ADDENDUM NO. 02

PROJECT: Newburgh Enlarged City School District
2019 Capital Improvements Project – Phase 3

CPL PROJECT NO. 13940.18

DATE: September 27, 2021

3 SECTION ATTIC 323
H203D 1/8" = 1'-0"

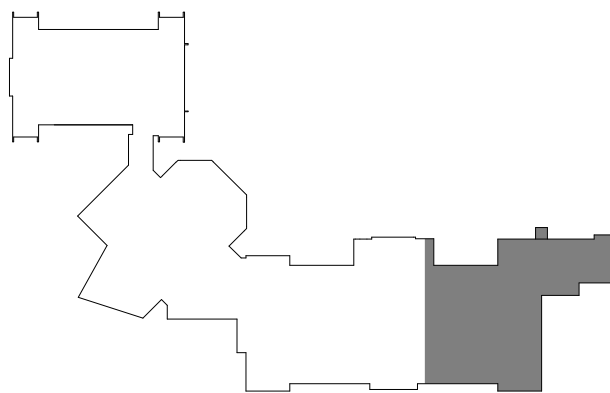
- 1 MOUNT UNIT VENTILATOR ABOVE CEILING. COORDINATE WITH ANY CEILING UTILITIES. MAINTAIN ACCESS FOR FILTER CHANGES. ALL SUPPLY AND RETURN DUCTWORK SHALL BE LINED. EXTEND EXISTING CONTROLS TO NEW UNIT LOCATION.
- 2 PLENUM RETURN.
- 3 EXHAUST FANS SHALL BE PROVIDED WITH NEW CURB. CONNECT TO EXISTING DUCT RISERS.
- 4 ROOFTOP UNIT SHALL BE PROVIDED WITH A NEW CURB. CONNECT TO EXISTING DUCT RISER.
- 5 UNIT VENTILATORS SHALL BE INSTALLED IN ATTIC SPACE. EACH DROP THROUGH CONCRETE FLOOR SHALL BE PROVIDED WITH NEW FIRE DAMPER.
- 6 PROVIDE FIRE DAMPER AT ALL FLOOR PENETRATIONS. ATTIC FLOOR IS CONCRETE.

1
E203D
THIRD FLOOR POWER AND SYSTEMS PLAN - AREA D
1/8" = 1'-0"

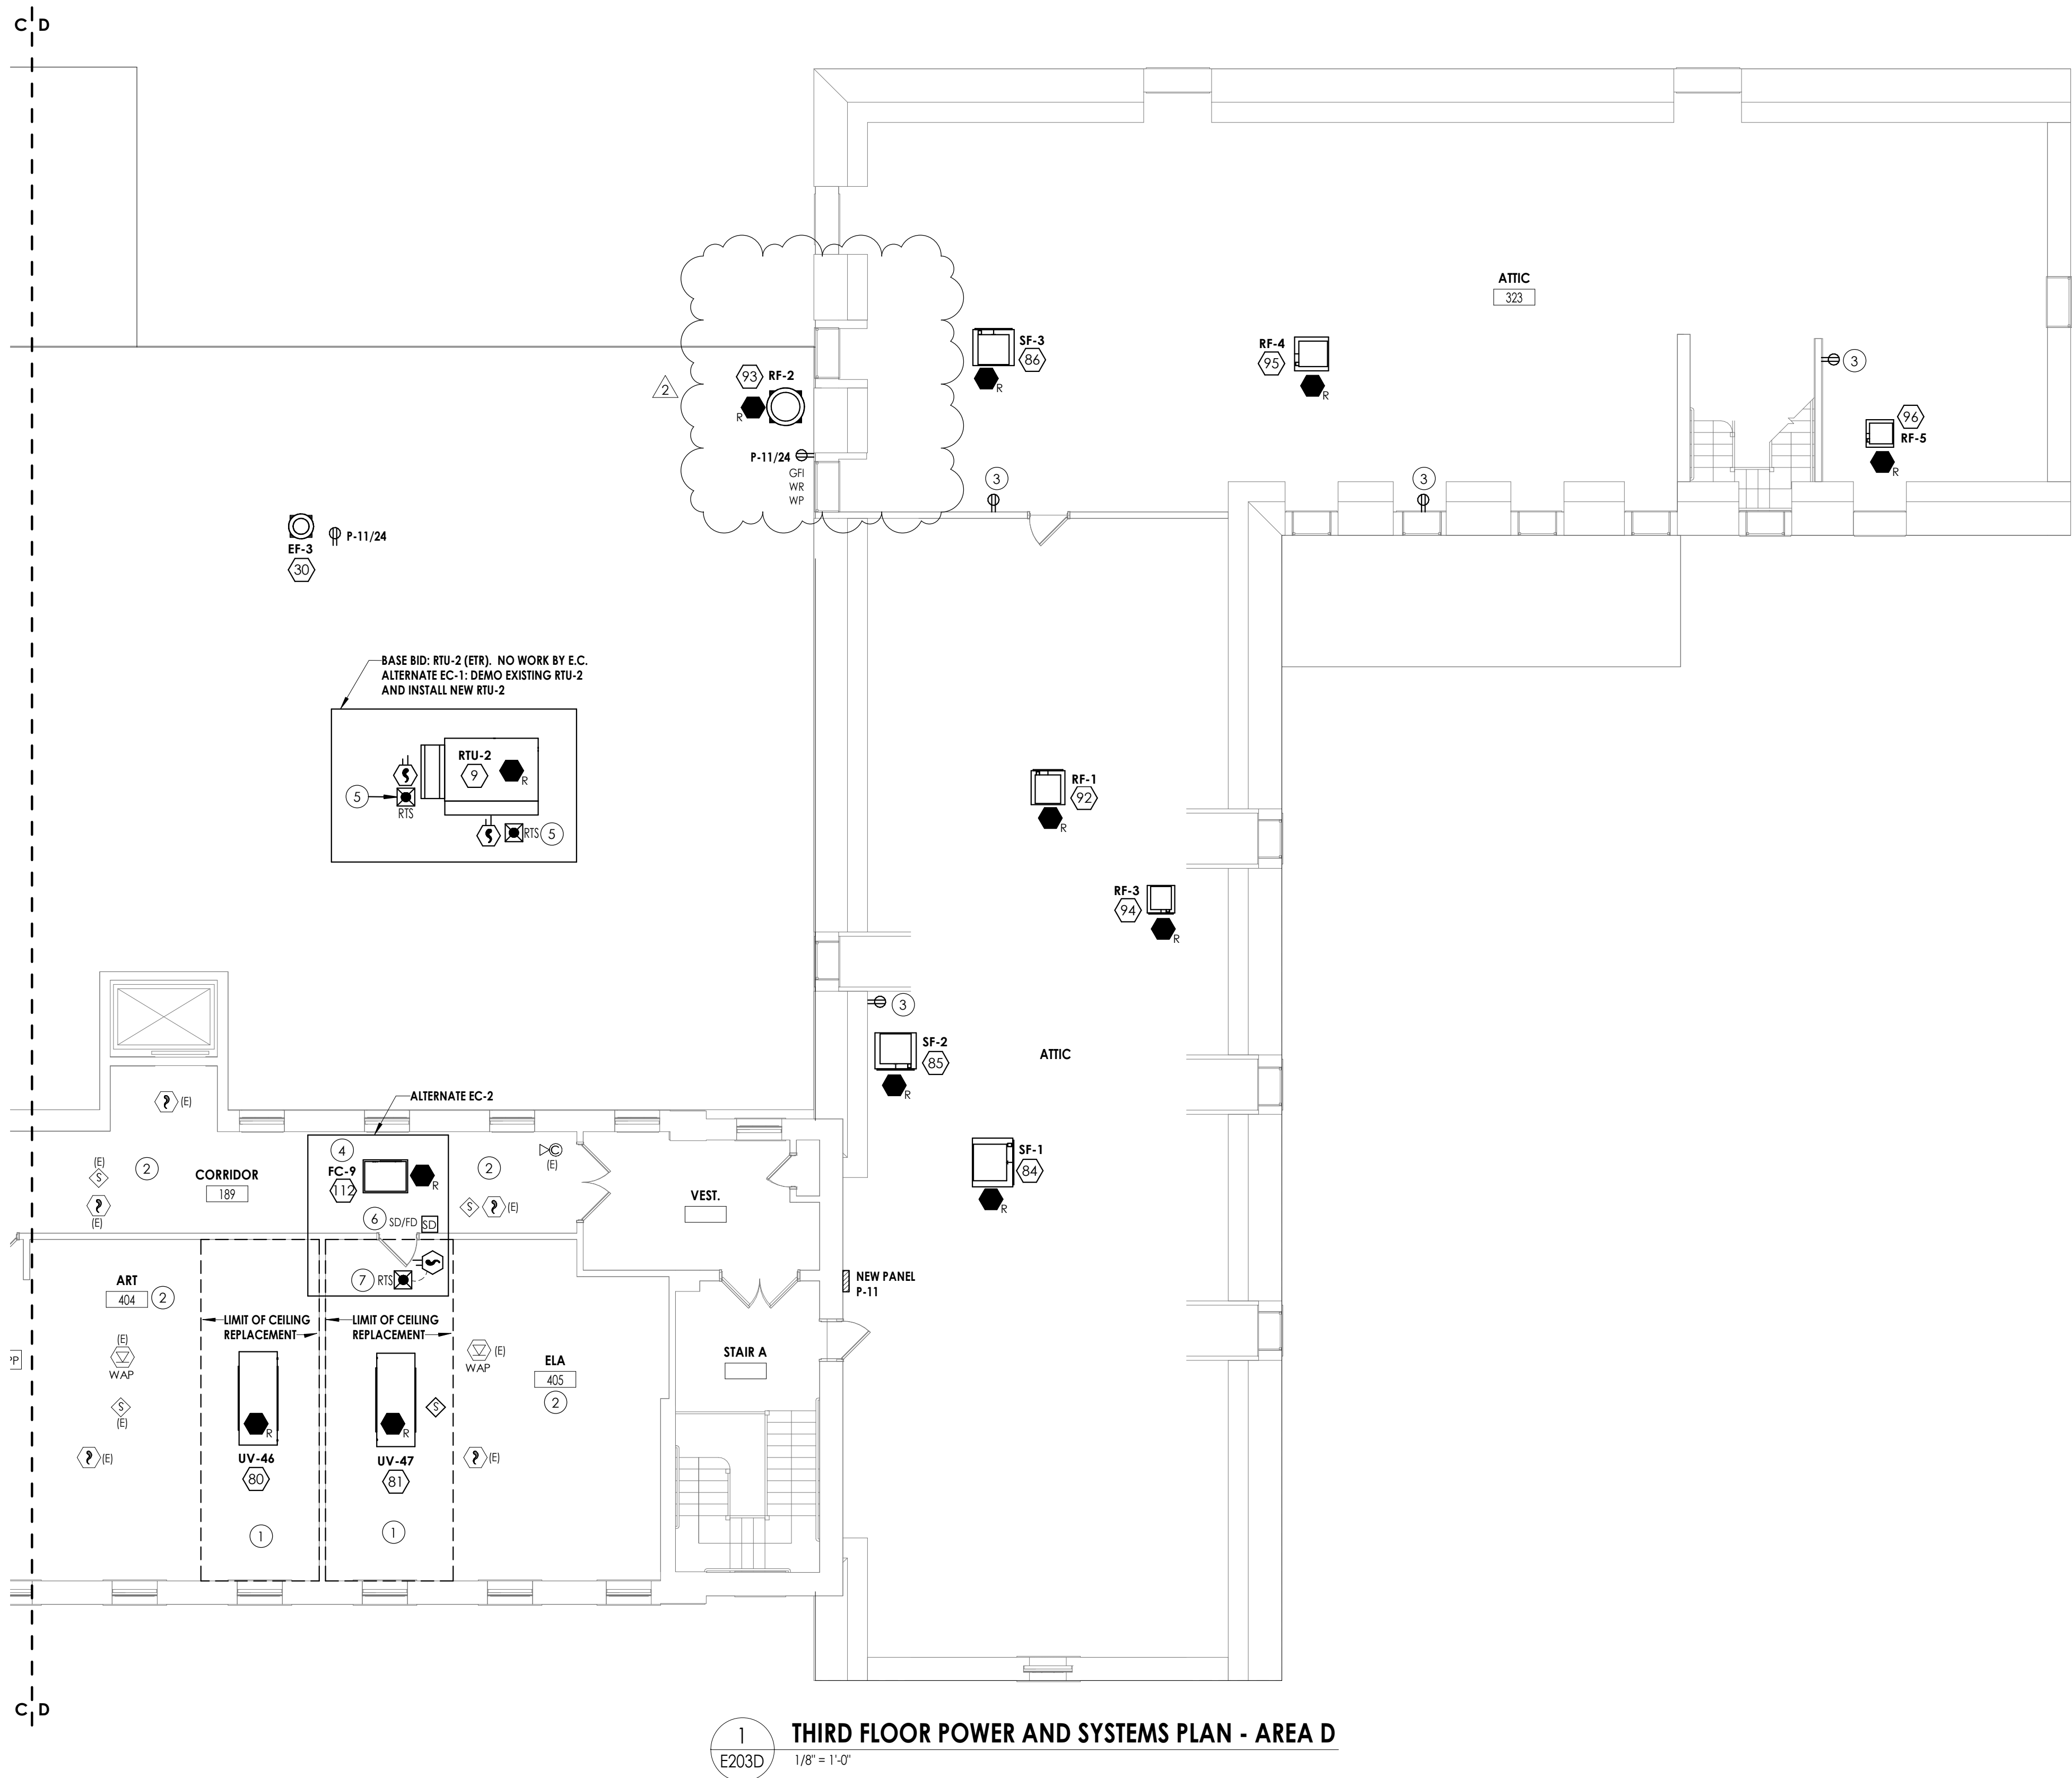
- 3.12 Drawing HMS E203D: Replace with the attached revised HMS E203D.
